Plexus Scientific Corporation

**Re: Current Lighting Solutions, LLC Responses to NRC's RAI dated November 14, 2019
– USNRC Mail Control Number 616865**

ATTACHMENT 2

**Samples of Design, Construction and Labeling of
GE Lighting and GE-Current Lamps Containing Kr-85 and Thorium**

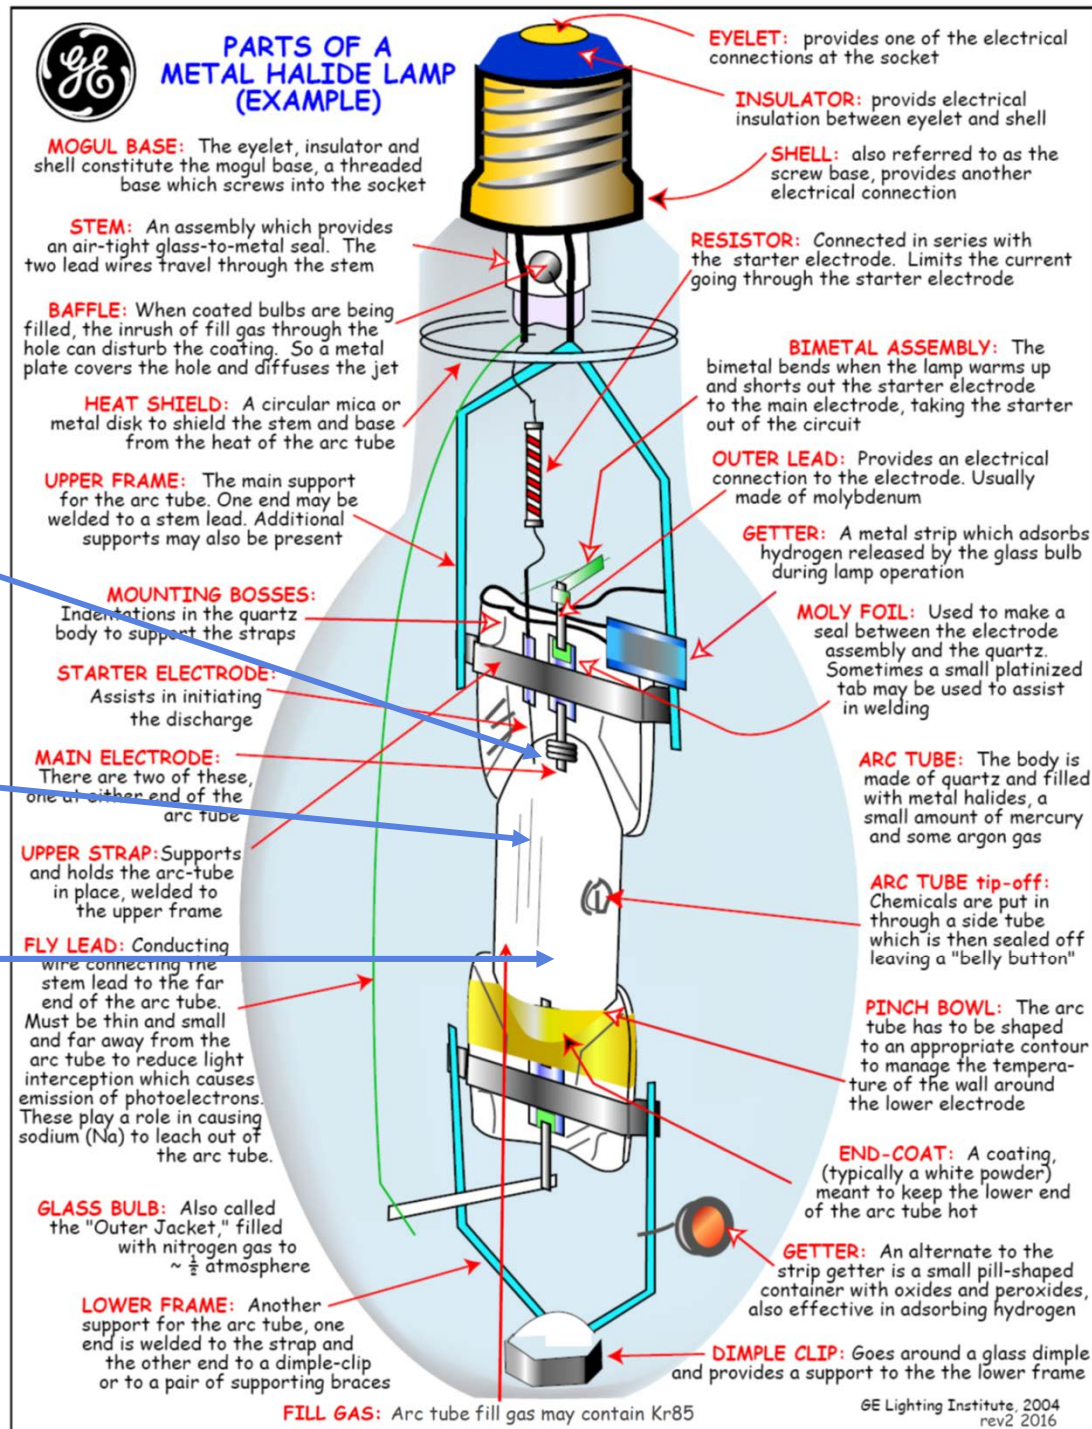
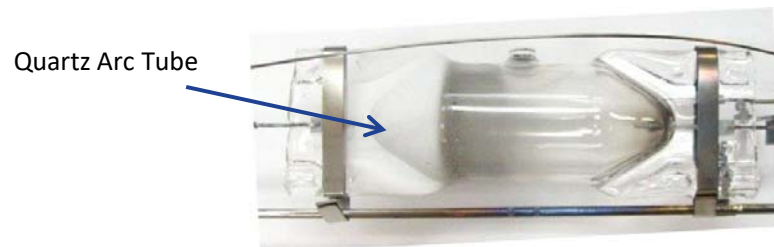
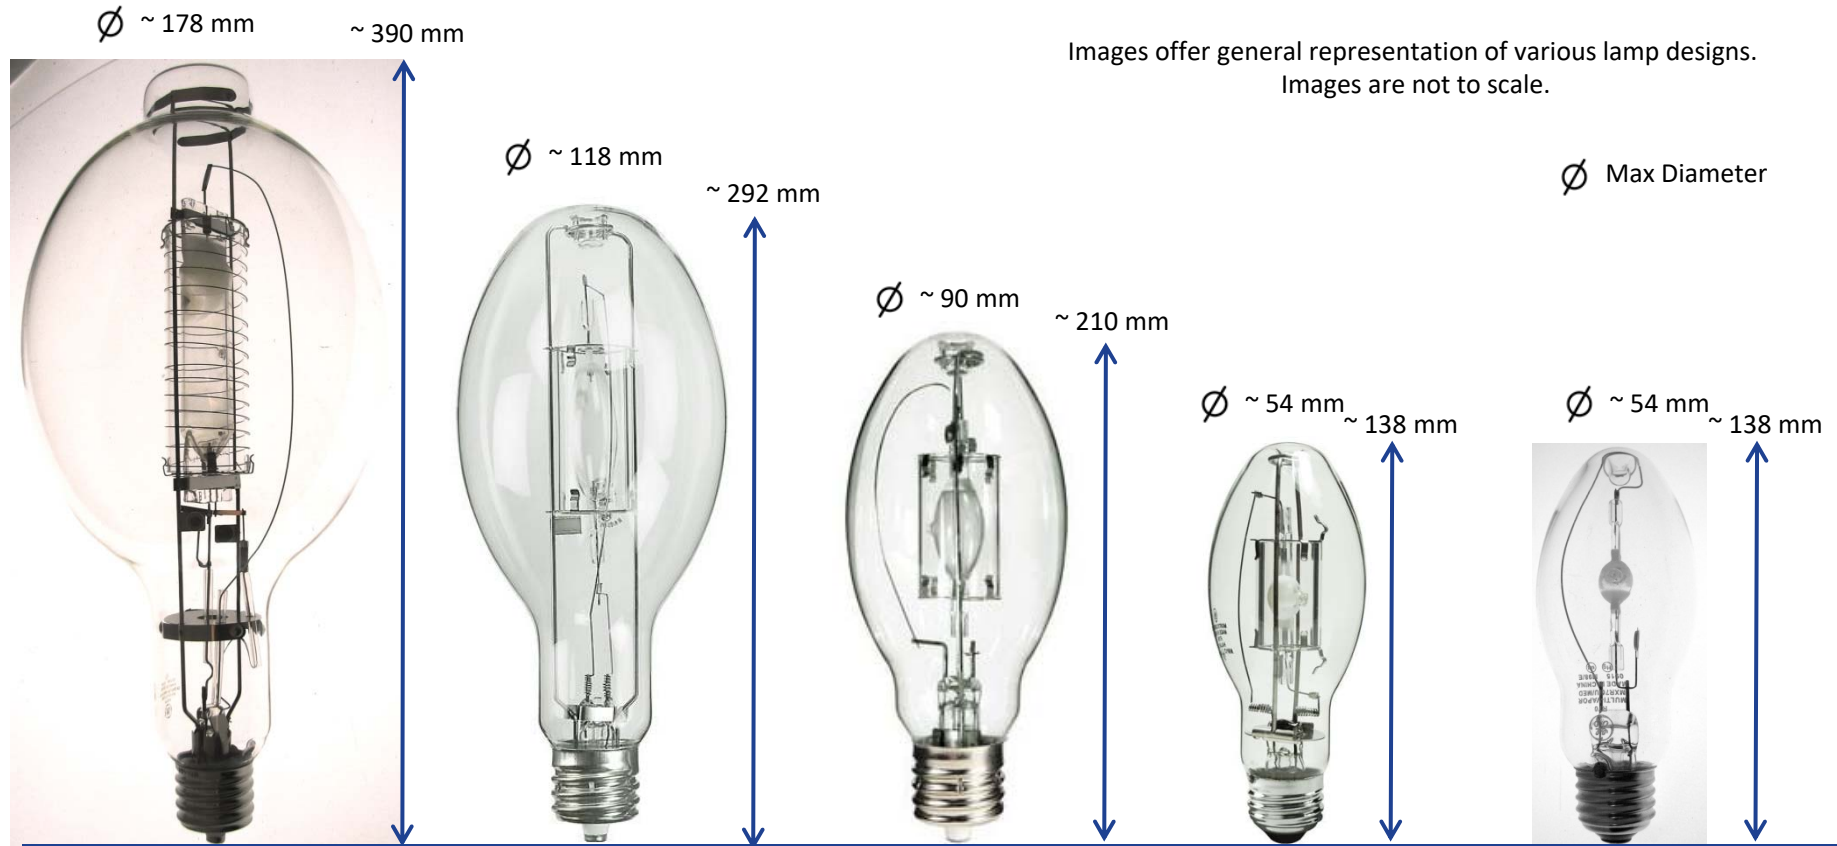
6. *10 CFR 40.52(b)(2) requires the applicant to submit details of construction and design of each product. Please resubmit this information in your revised application to take into account the inclusion of thorium. Please provide descriptive text of the construction and design of each product.*

Response: Small amounts of thorium are hermetically sealed within a quartz arc tube, and the arc tube is mechanically secured and further hermetically sealed within a second outer glass or quartz bulb. Industry proven manufacturing techniques that have been in existence for 40-50 years or longer maintain the thorium within the lamp and prevent release under normal transport and operating conditions. Attachment 2 contains an example schematic which shows the locations of the thorium inside the lamp.

Thorium oxide may be alloyed in the tungsten electrodes.

Thorium iodide may be present as admixture in the dose chemistry.

Arc tube fill gas may contain Kr-85

All byproduct is contained inside the hermetically sealed quartz arc tube.
